Objection to Planning Application DC/26/0934

Bakery Cottage, Henfield Road, Cowfold RH13 8DR

We are writing to Comment on the Planning Application DC/26/0934 “Demolition of existing vacant storage buildings and erection of 9no. residential units, provision of open space and retention of pond”

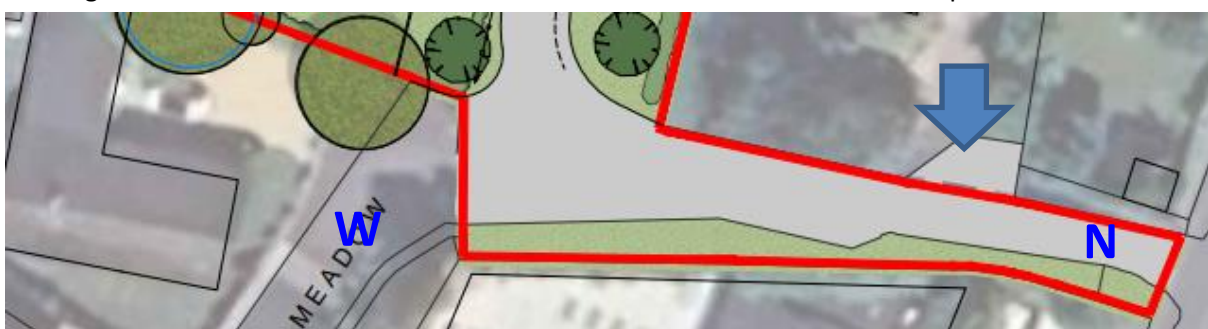
Take a look at the satellite image below and compare the width of the "housing estate road "W" with the narrow entrance "N".

Note the indentation shown on the plans in the planning application and at the entrance and arrowed below, and which looks like a parking or passing place is NOT REAL.

It is the turn into a private driveway and cannot be used as a passing or parking space.

Note again the difference in width of the narrow road allowed for in the development at the

southern end of Summer Meadow ("W") compared with the width of the entrance "N". This entrance cannot be widened. W allows two cars to pass; N does not allow two cars turning in or exiting to pass each other. Maybe it is formally within inches of being wide enough. Just try it or simply watch cars entering and exiting.

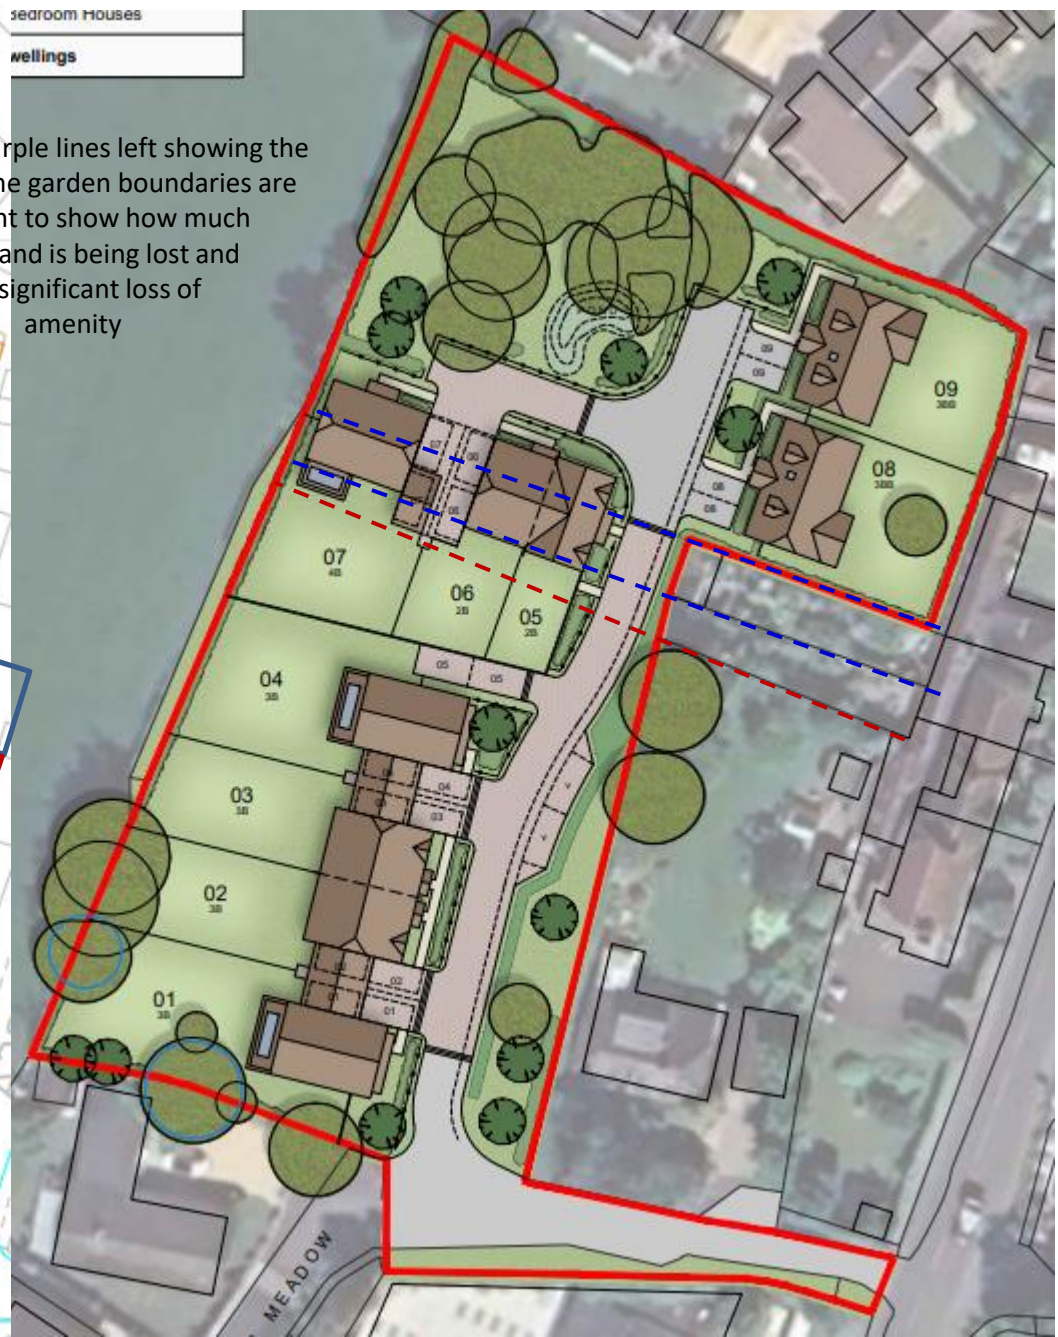
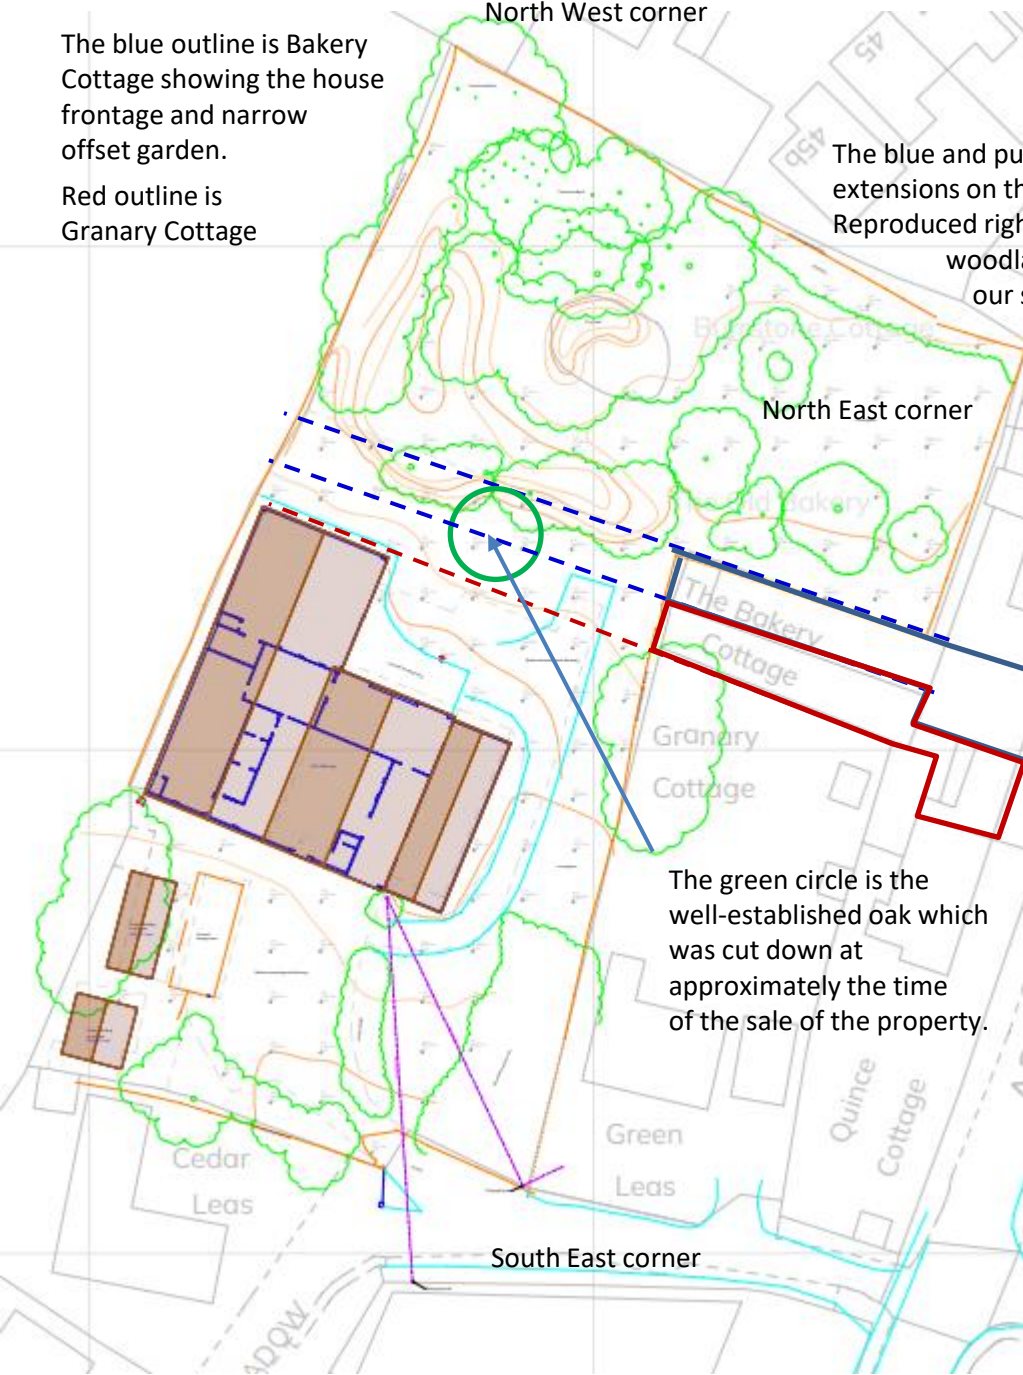
The blue outline is Bakery Cottage showing the house frontage and narrow offset garden.

Red outline is Granary Cottage

The blue and purple lines left showing the extensions on the garden boundaries are Reproduced right to show how much woodland is being lost and our significant loss of amenity

The green circle is the well-established oak which was cut down at approximately the time of the sale of the property.

To show the extent of the **loss of woodland (shaw)**, we have superimposed the proposed “accommodation schedule” as closely to scale as we can on the original topography drawing.

Under 40% of the original areas is being retained. See the third page below.

The purple arrow denotes approximately the location of a large pile of rotting wood, which formed a wonderful habitat for invertebrates and mammals. This was cleared around the time of the sale of the property, and needs to be restored there or elsewhere on the property, although it will take time for the lost wild-life to re-establish itself.

The habitat management and Monitoring plan makes a great fuss about the retention of the woodland (their description) in the SE corner of the plot.

As we can see by comparing the topography map showing the canopy in this corner with the superimposed accommodation schedule, only one small tree is being retained, the rest is cleared and two new trees planted.

In this drawing we have taken the outline of the woodland proposed to be retained in the Northwest of the property and superimposed three copies on the topographical survey. The third outline is deemed to have been split at the blue line.

As near as dam it, three outlines fit the old green and wooded space, suggesting only 33% of the original woodland (shaw) and coppiced trees are being retained.
